## Product Change Notification / KSRA-18BGHS695

CCB 4559 Initial Notice: Qualification of SIGN as a new assembly site for selected SST39LFxxxx and SST39VFxxxx device families available in 48L TSOP (12x20mm) package.

**CCB 4559**  
**Pre and Post Change Summary**  
**PCN # KSRA-18BGHS695**

# Lead frame Comparison

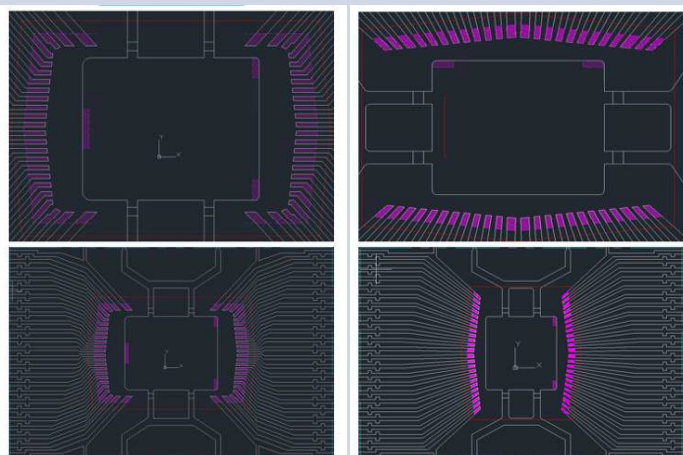
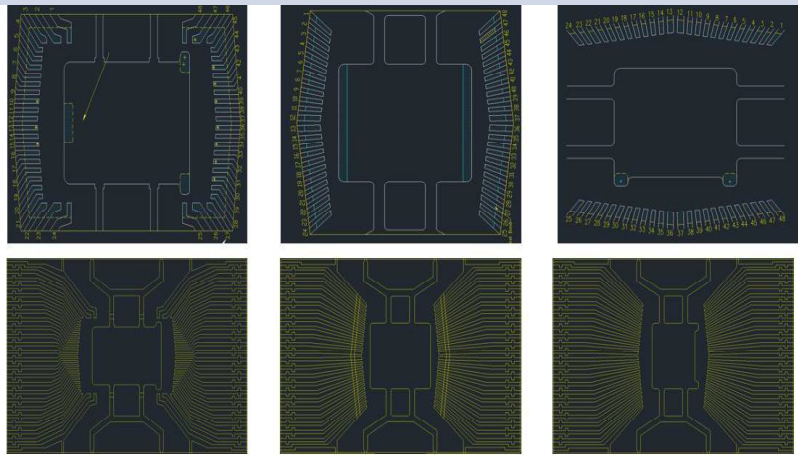
Pre Change  
LPI

Post Change  
SIGN

Assembled at LPI using lead frame with paddle size 207x142mils, 183x161mils or 160x130mils.

Assembled at SIGN using lead frame with paddle size 209x165mils or 159x165mils
